SUBJECT: Forwards info requested in SSER 5 (NUREG-0857) retests performed for C-E on load limiting devices in reactor vessel lower key horizontal supports.

Subject: Palo Verde Nuclear Generating Station (PVNGS)  
Units 1, 2 and 3  
Docket Nos. STN-50-528/529/530  
File: 84-056-026; G.1.01.10; D.4.02.1

ATTACHMENT 1: Revision to FSAR Section 3.9.1.4.1  
SEISMIC CATEGORY I NSSS ITEMS

ATTACHMENT 2: Draft FSAR Figure 3.9-1  
REACTOR VESSEL LOWER KEY LOAD LIMITER REQUIREMENTS AND TEST RESULTS

REACTOR VESSEL LOWER KEY  
LOAD LIMITER REQUIREMENTS  
AND TEST RESULTS

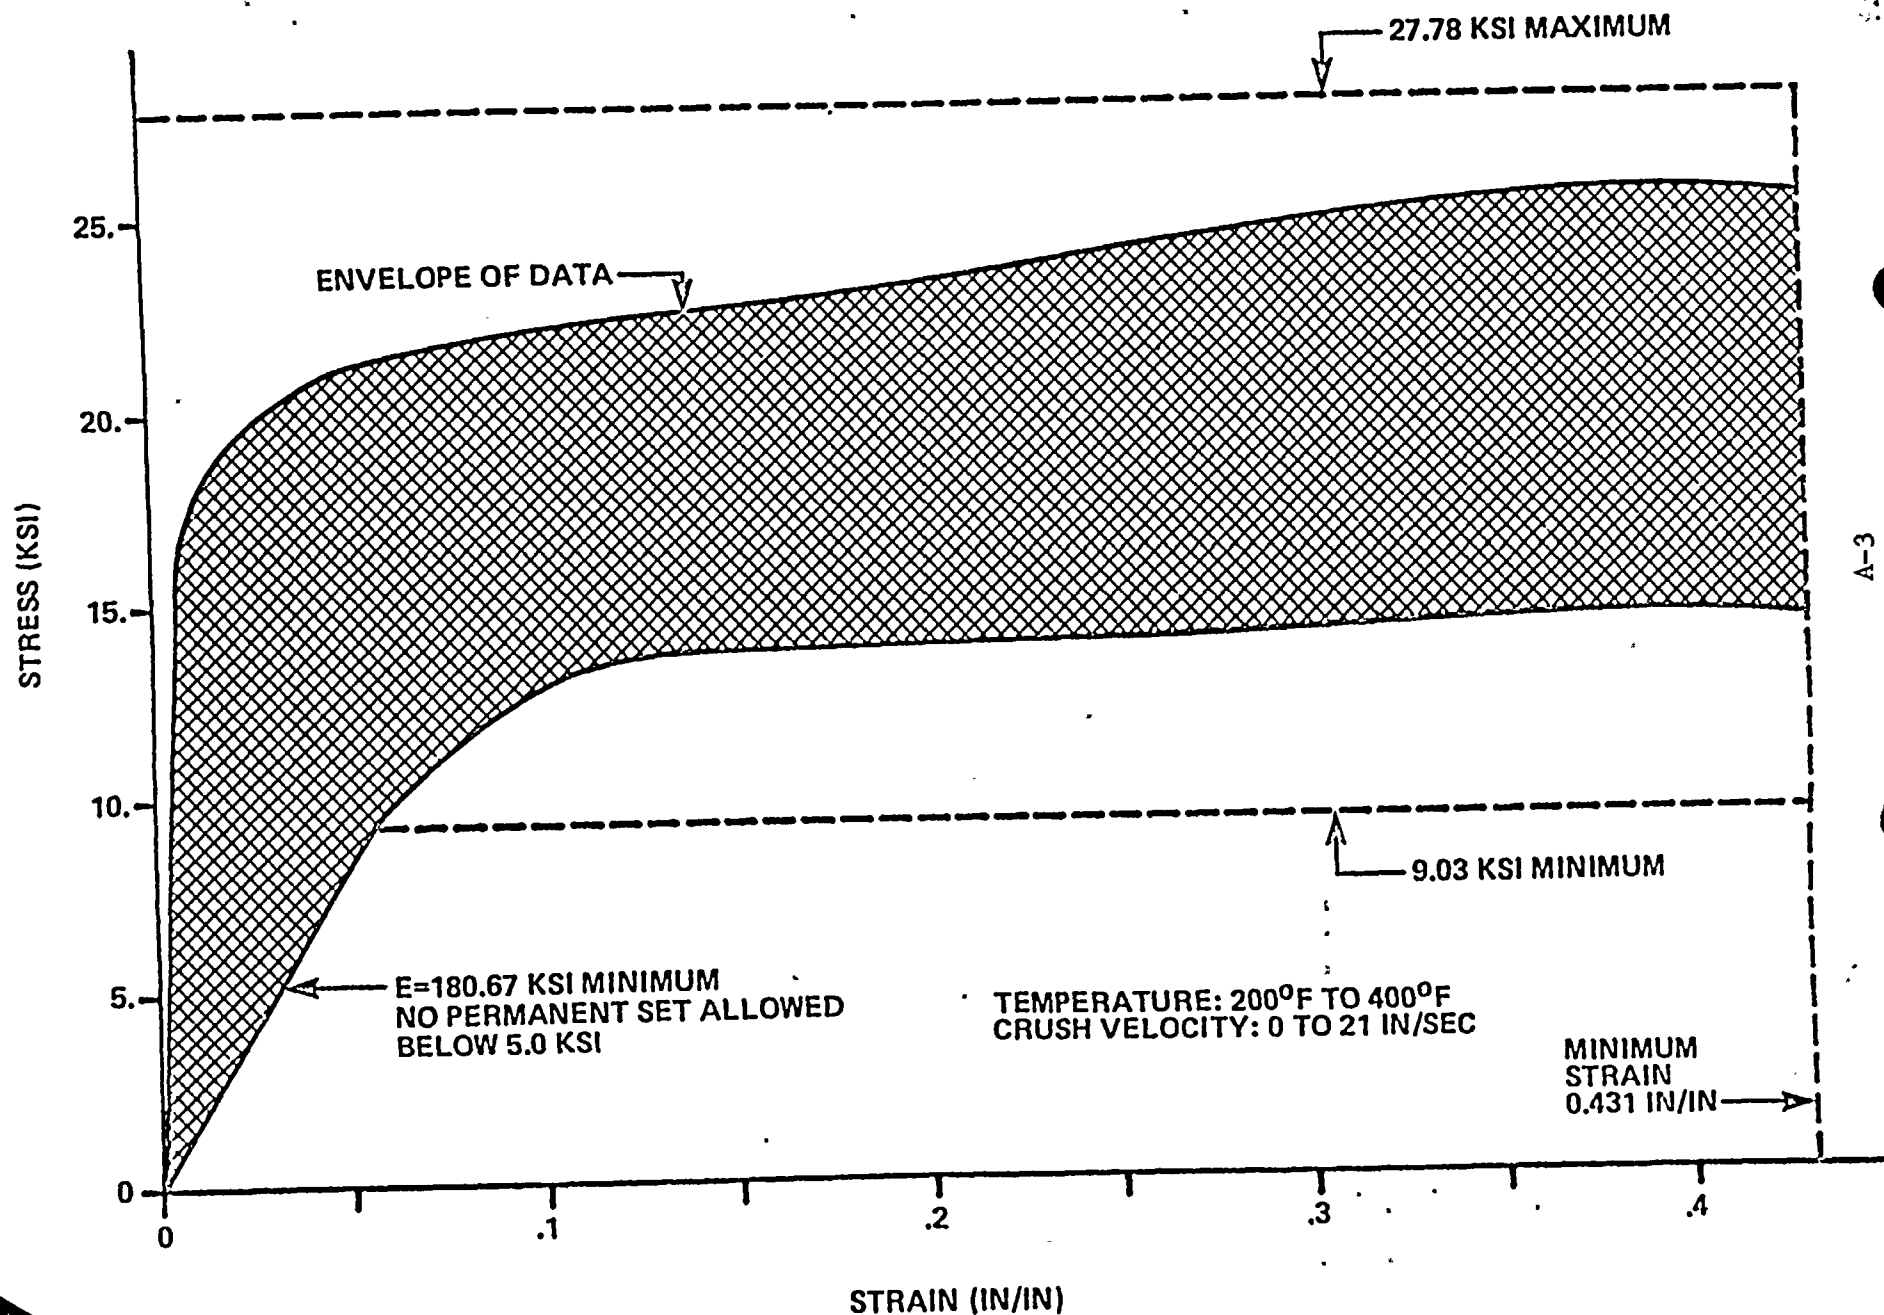
- (i) Submit figure 3.9.1-6b [as stated in Reference (B)]: "Reactor Vessel Lower Key Load Limiter Requirements".
- (ii) Submit a description of what testing was done and what the test results mean.

Figure 3.9-1 (see page A-3) illustrates the performance requirements specified for the reactor vessel lower support key load limiters. The dashed lines represent the stiffness and load ranges evaluated in the overall system analysis. The test data points were within the envelope indicated by the solid lines. The testing was performed on samples extracted from the heat specific material used in construction.

Twenty-one tests were run at various temperatures and at crush velocities representative of performance requirements. The test results were within the specified load deflection limits.

FIGURE 1

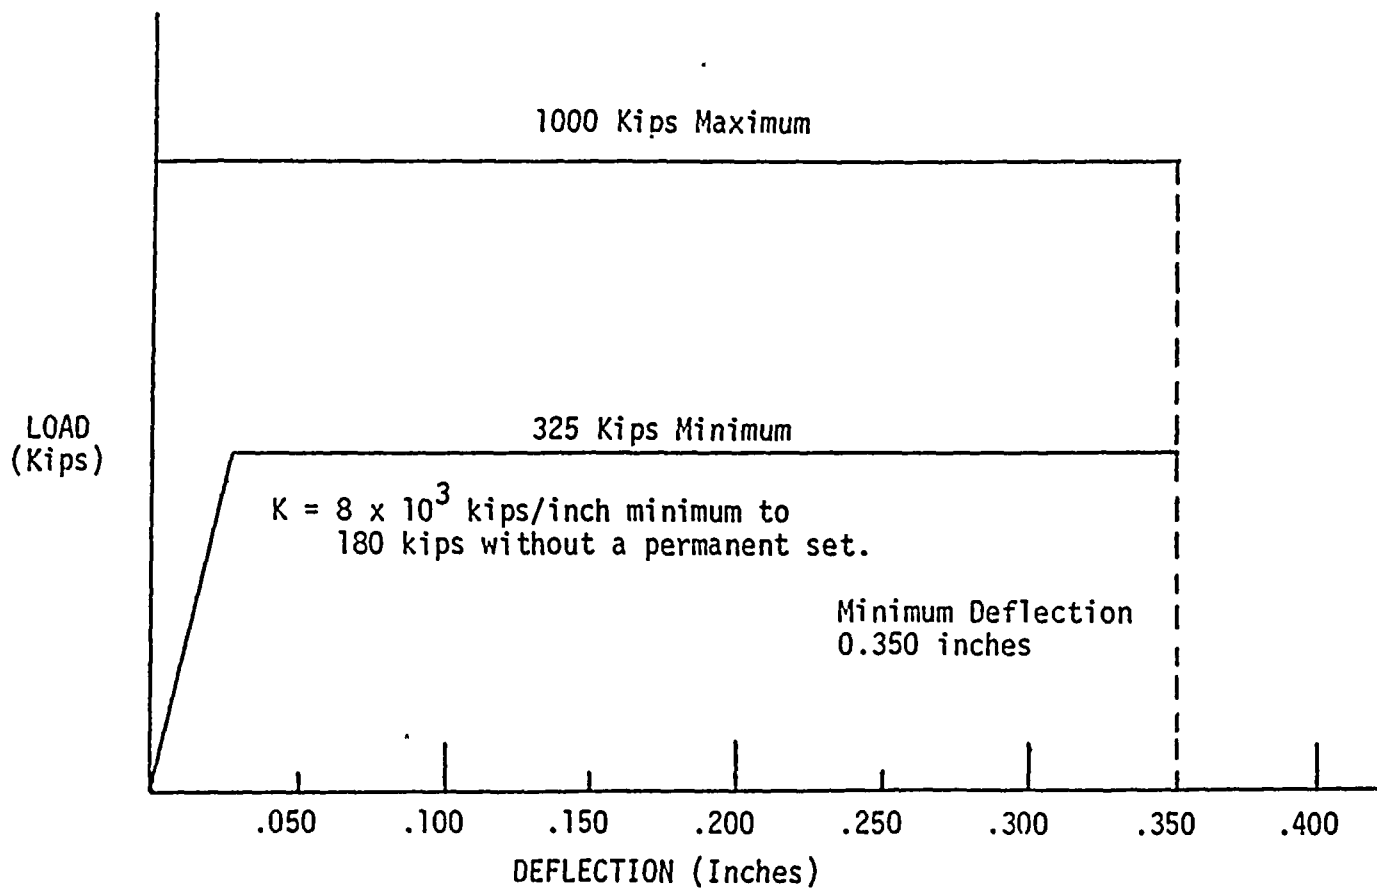
A test program was performed to verify that the honeycomb material meets C-E's design requirements. The design requirements are shown on Figure 1 and are summarized as follows:

1. The honeycomb will maintain a minimum stiffness of  $8 \times 10^3$  kips/inch up to 180 kips without a permanent set.
2. The honeycomb will crush within a load band of 325 kips to 1000 kips.
3. The honeycomb will have a minimum deflection of 0.350 inches.
4. The above three requirements apply over a temperature range of 200°F to 400°F and a crush velocity range from 0 to 21 inches/second.
